UNITED STATES ENVIRONMENTAL PROTECTION AGENCY  
REGION 10  
1200 Sixth Avenue, Suite 900  
Seattle, Washington 98101-3140

RE: EPA Comments on the March 2010 Methods Development QAPP

### EPA Comments on the Sturgeon Studies Method Development Components of the March 2010 UCR Draft QAPP Methods Development for Sediment Sampling and White Sturgeon Sediment Toxicity Studies.

## ATTACHMENT 2 – REVISED SAMPLING LOCATION

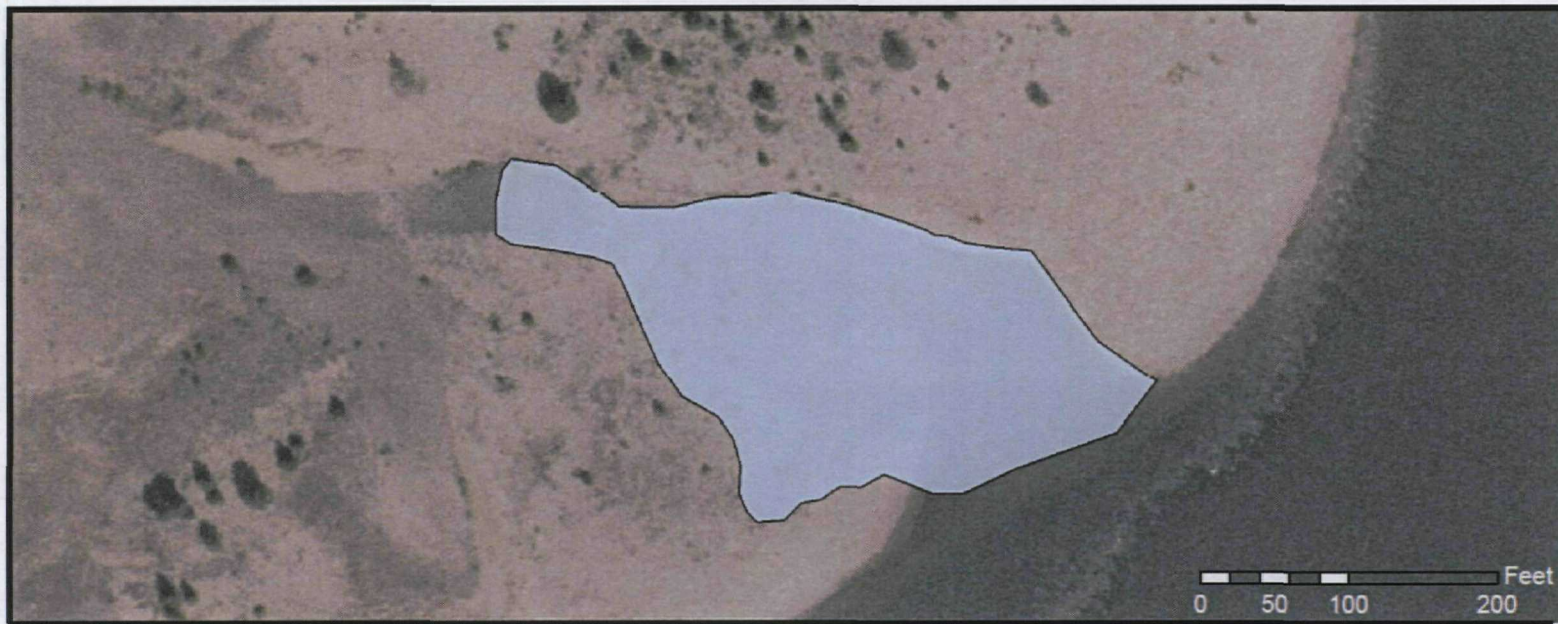
Sampling for the sturgeon methods development work in the U.S. will be conducted from within a polygon at Deadman's Eddy. The sampling area / polygon (see figure below) is currently under cultural resources review. Please note that page 3-1 of the Cultural Resources Coordination Plan will need to be revised to reflect the revised sampling location, the use of shovel(s) for sample collection, and other revisions, as appropriate. Samples may be collected from a depth of up to 12 inches.
